PAINT BRUSH HILLS FILING NO. 14

GRADING AND EROSION CONTROL PLANS

EL PASO COUNTY FILE NO. SF-20-024

GRADING & EROSION CONTROL COVER SHEET
PAINT BRUSH HILLS FILING NO. 14
JOB NO. 10-014
DATE PREPARED: JANUARY 22, 2021
DATE REVISED:

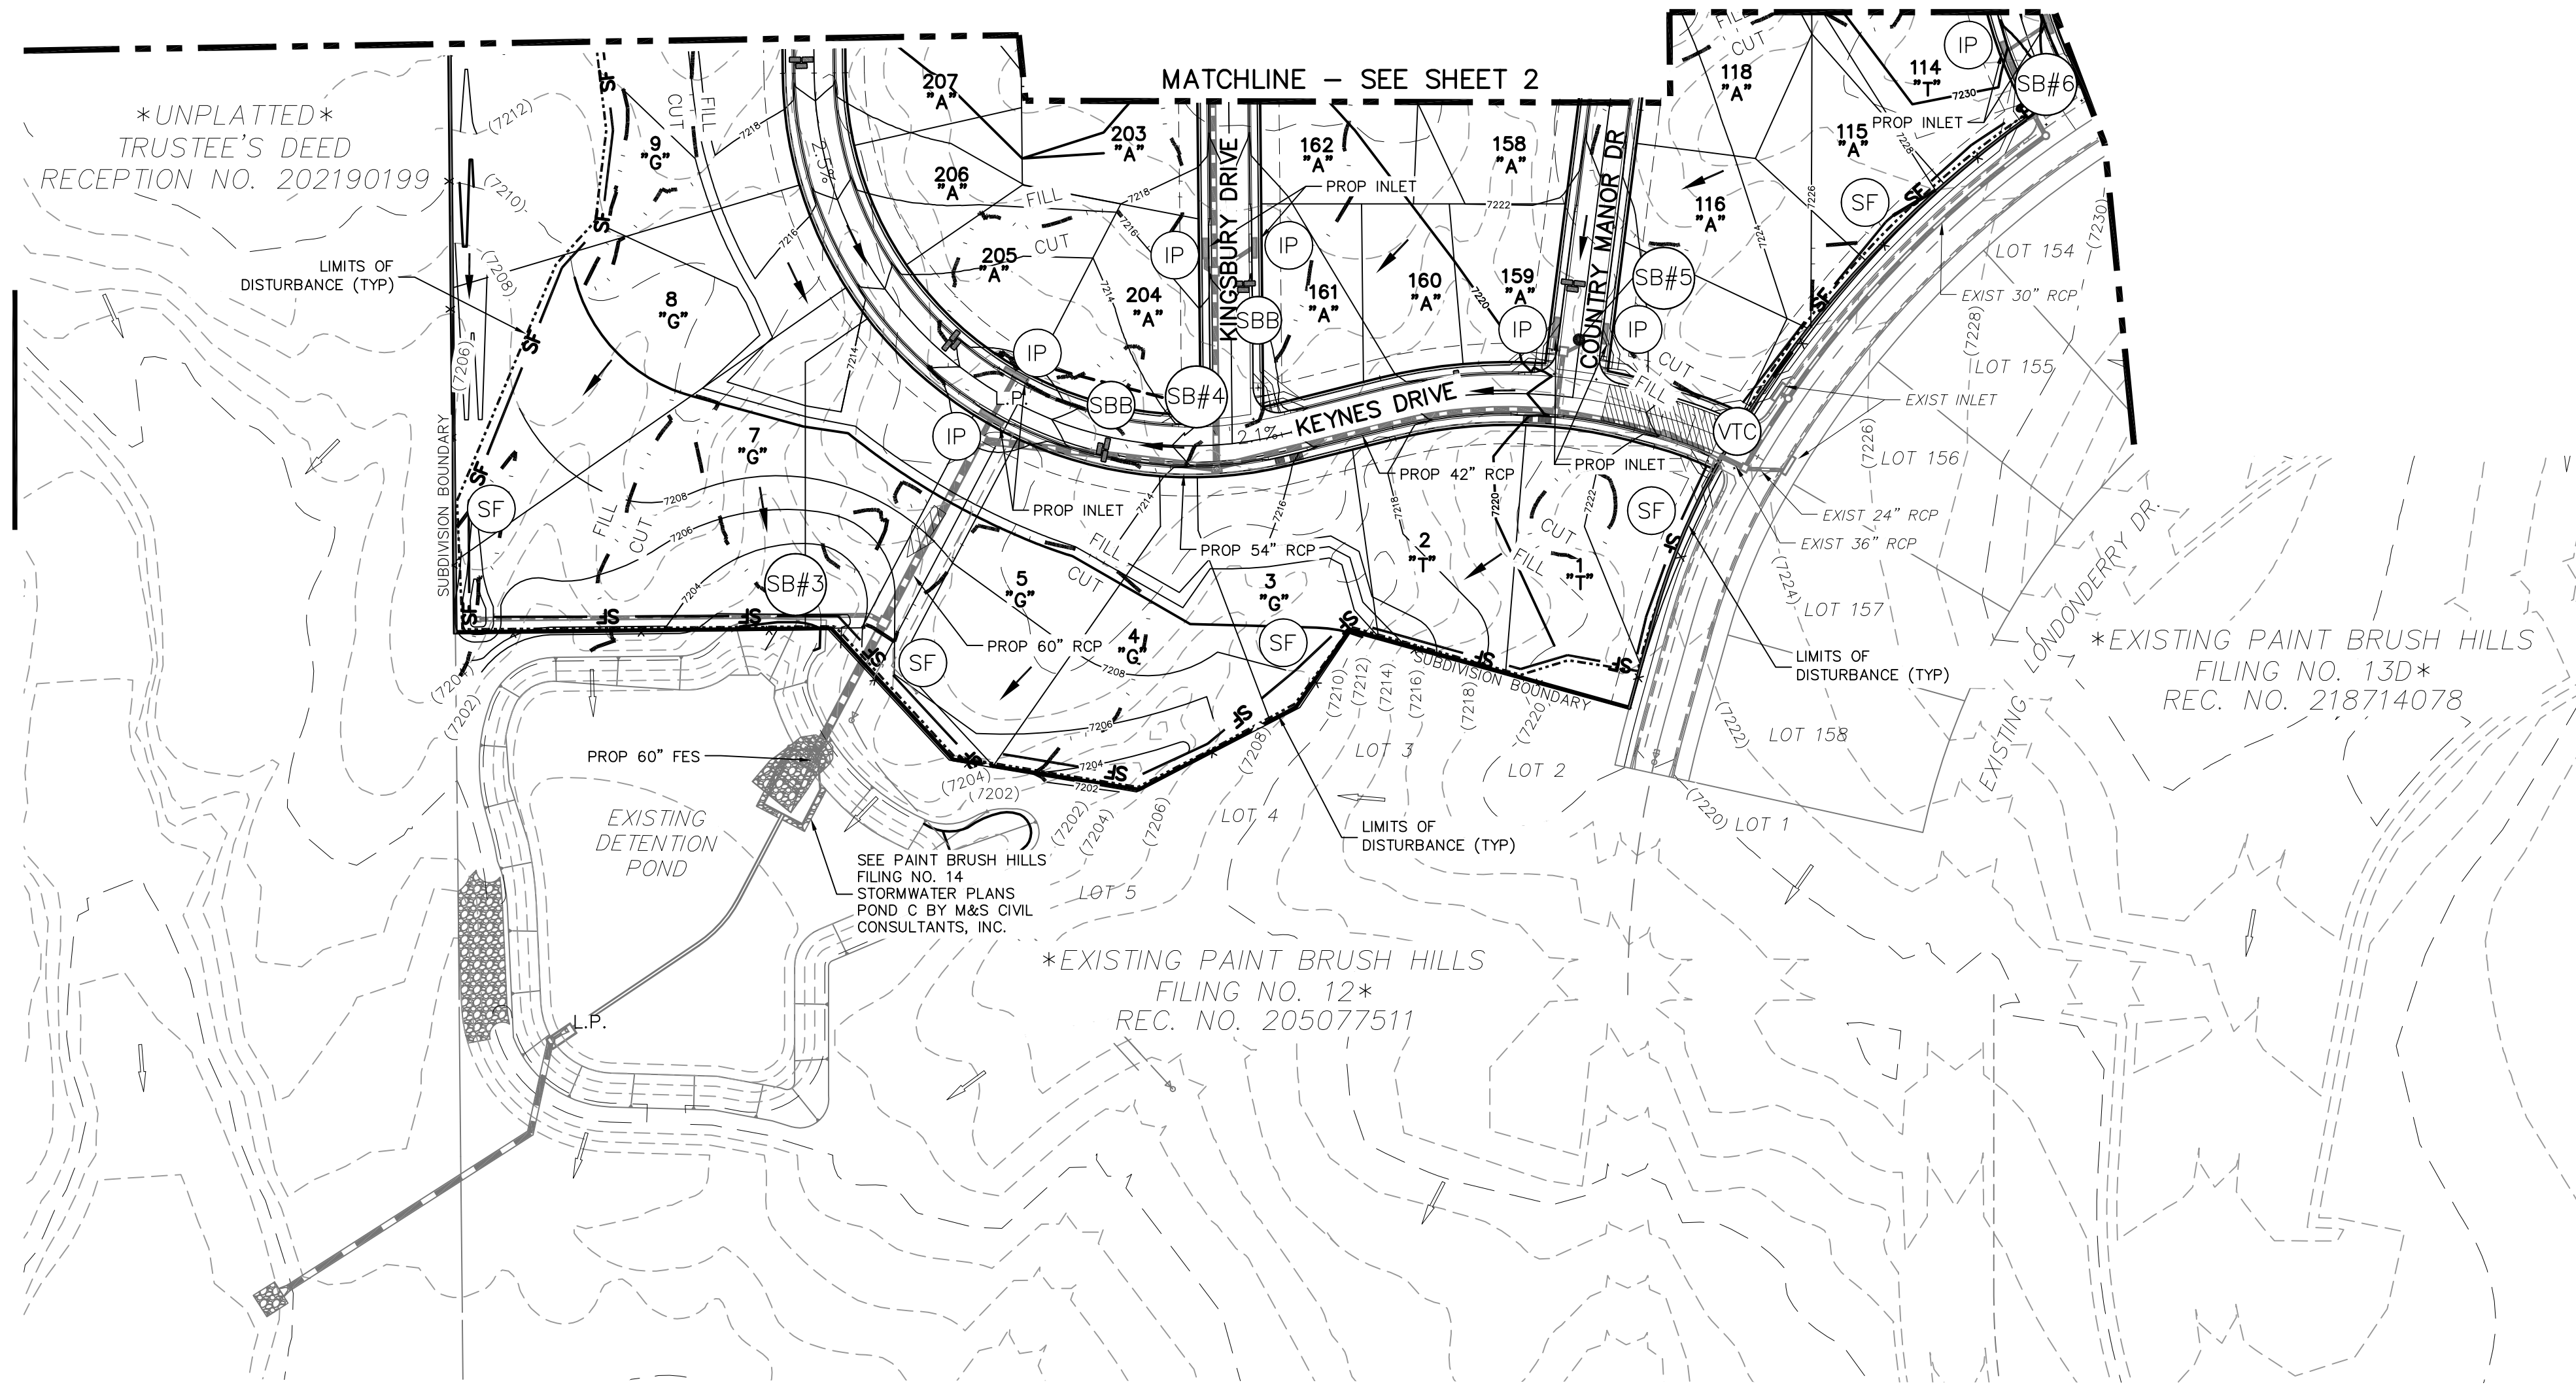
Tract A. However, after reviewing the new preliminary grading plan County Parks has concerns about a proposed storm drain and site grading located within Tract A near Lot 26. The provided grading plan shows a 36" RCP storm pipe, 15-foot access road, and grading within Tract A to create a swale and stormwater detention. These stormwater improvements are shown encompassing the entire width of Tract A between lots 25 and 30, making the construction of a regional trail impossible for over 800 feet. Due to this conflict, County Parks requests the applicant remove the stormwater improvements from Tract A so that the regional trail can be constructed. Alternatively, the landowner could provide a trail easement within lots 24 through 30 to bypass the stormwater improvements and allow for the construction of the regional trail.

Please address Parks
comments in plat and
prelim submittal.

is there an agreement
in the works?
